LOS ESTEROS CRITICAL ENERGY FACILITY
AMENDMENT 4

**LOS ESTEROS CRITICAL ENERGY FACILITY
AMENDMENT #4 For 1-AFC-12**

Prepared for
LOS ESTEROS CRITICAL ENERGY FACILITY, LLC

October 2009

Figure 2.2-2

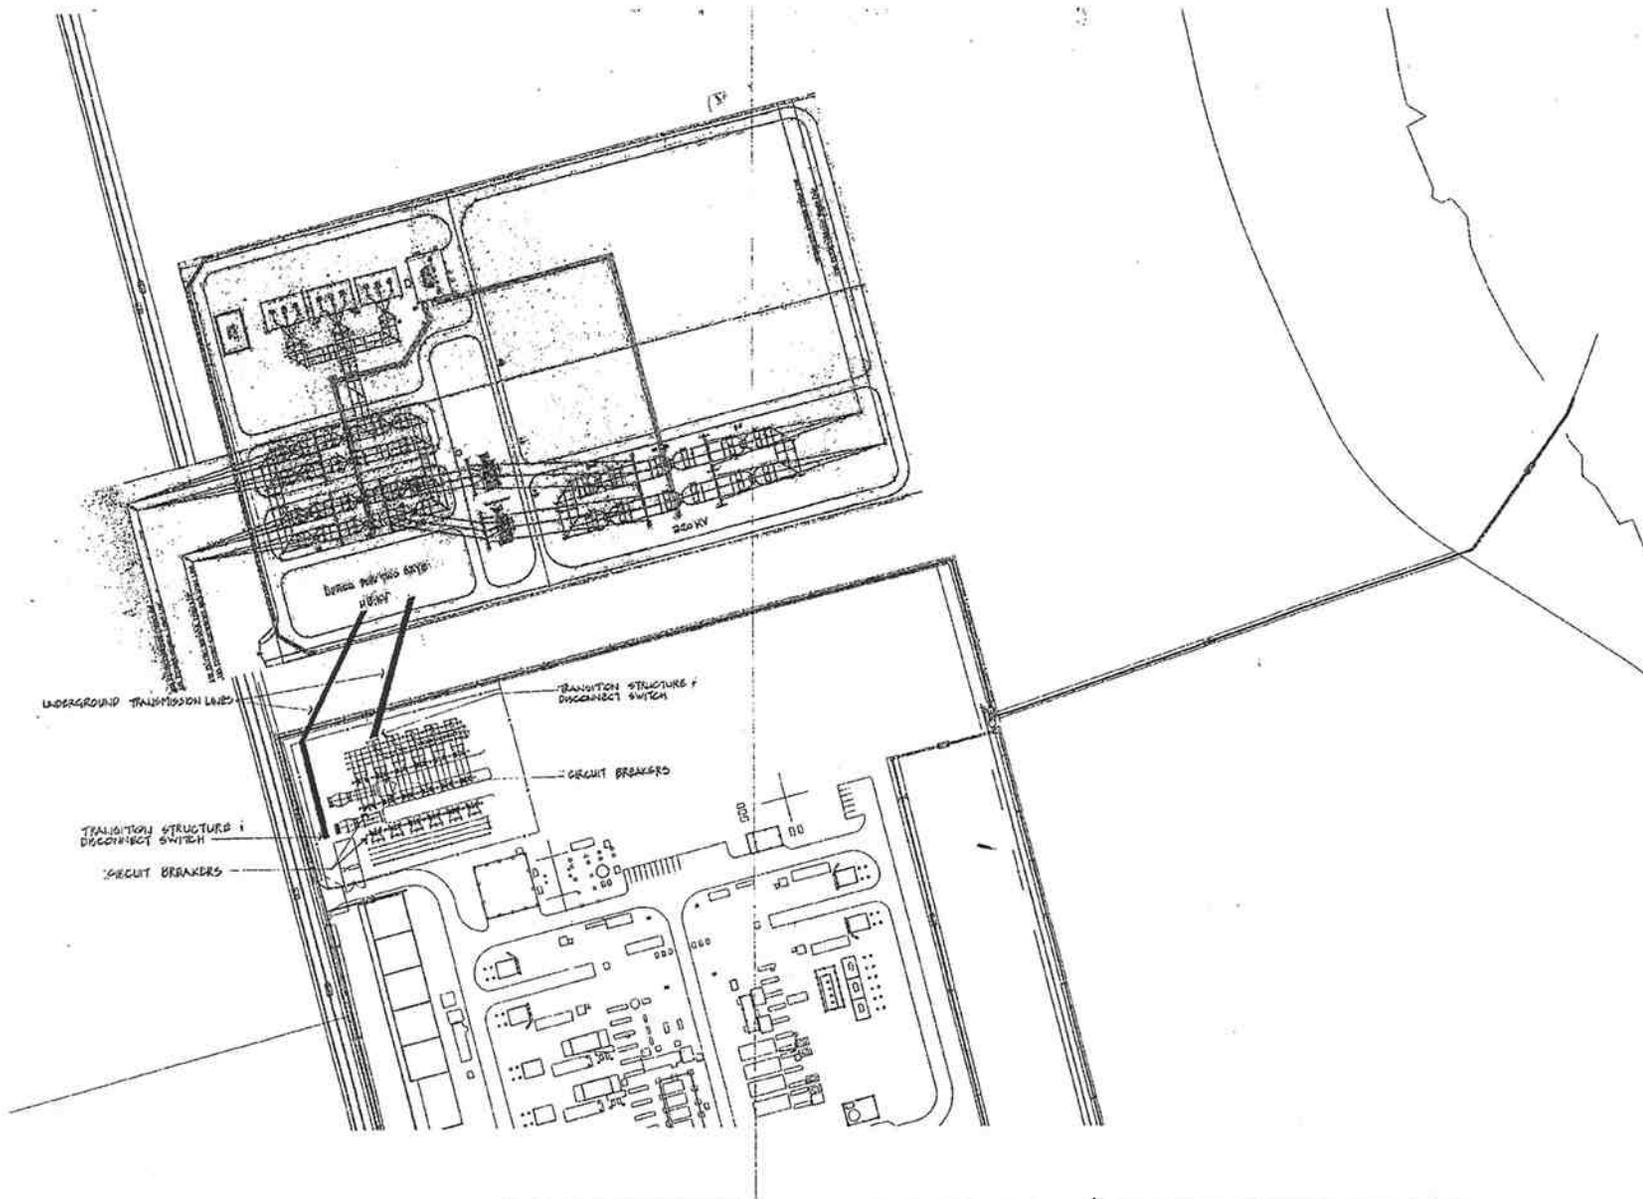
Currently, LECEF is interconnected to PG&E's Los Esteros-Nortech 115 kV circuit by way of a 152 foot overhead transmission line. Petitioner requests that the Commission reinstate the 2002 Decision's approval of Petitioner's proposed permanent underground interconnection to the PG&E Los Esteros Substation. This proposed electrical transmission interconnection will connect LECEF to PG&E's grid by way of two new underground three-phase, single-circuit, solid-dielectric, copper-conductor circuits between LECEF's Air Insulated Substation (AIS) and the adjacent Los Esteros 115 kV switchyard. (Figure 2.1-1.) As a result of LECEF's physical proximity to the Los Esteros Substation site, the two transmission circuits will exit the switchyard underground and run to the northwest for approximately 400 feet where they will resurface and be connected to the 115 kV switchyard. Figure 2.2-1 shows the location of the preferred electrical interconnection arrangement. The two 115 kV circuits will each be rated to allow for the removal of one of the circuits without limiting plant output.

The interconnection will not require an additional right-of-way. The underground line will run under property owned by Petitioner, PG&E and the City of Santa Clara. Petitioner granted the City of Santa Clara this property in 2003,² and the grant deed reserved an easement for underground lines. An electrical one-line diagram of the proposed LECEF to the Los Esteros Substation interconnection appears on Figure 2.2-2. Each circuit will be comprised of two (2) solid-dielectric, 2500 kcmil, copper conductors per phase. Each conductor will be installed in a separate underground conduit. The conduit system will begin beneath the LECEF AIS, run northwest, and resurface within the Los Esteros 115 kV switchyard. Once aboveground within the Los Esteros Substation, the 115 kV circuits will be connected to existing 115 kV facilities. (See Figure 2.2-2.)
